**Subject** ▶ Modifications in Handle Base

**For Models** ▶ HM1800

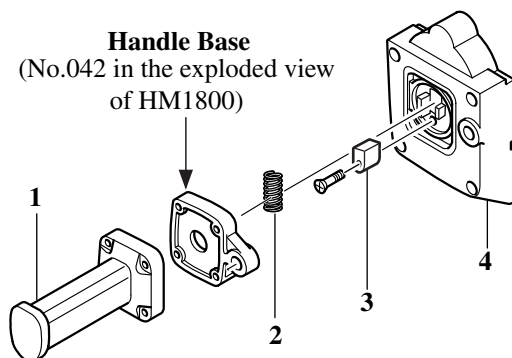
**Description** ▶ In order to improve Handle Base and Gear Housing Cover in durability against Compression Spring 12, Handle Base has been modified as described below.

Another Handle Base (No.094 in the exploded view) has been replaced by the new one at the same time.

▶ Current	▶ New
<p>[View from the side of Gear Housing Cover]</p> <p><b>Part No.322847-5</b></p>	<p>See below for detailed information on modifications.</p> <p><b>Part No.324062-7</b></p>
<p>[Cross Section]</p> <p><b>Handle Base</b></p> <ol style="list-style-type: none"> <li>1. Side Handle</li> <li>2. Compression Spring 12</li> <li>3. Rubber Sleeve</li> <li>4. Gear Housing Cover</li> </ol>	<p><b>Modifications:</b></p> <ol style="list-style-type: none"> <li>1) The surface that contacts with the top of Compression Spring 12 has been enlarged (See the encircled area in Cross Section.) in order to disperse more effectively the spring's tension power against Gear Housing Cover.</li> <li>2) The way of heat treatment has been changed for more durable surfaces that receive Compression Spring 12.</li> </ol>

Item No.	Current part		Q'ty	I/C	New part		Q'ty	Note
042 094	Handle Base 322847-5		2	←	Handle Base 324062-7		2

From serial No.18055E (Mar.,2000)
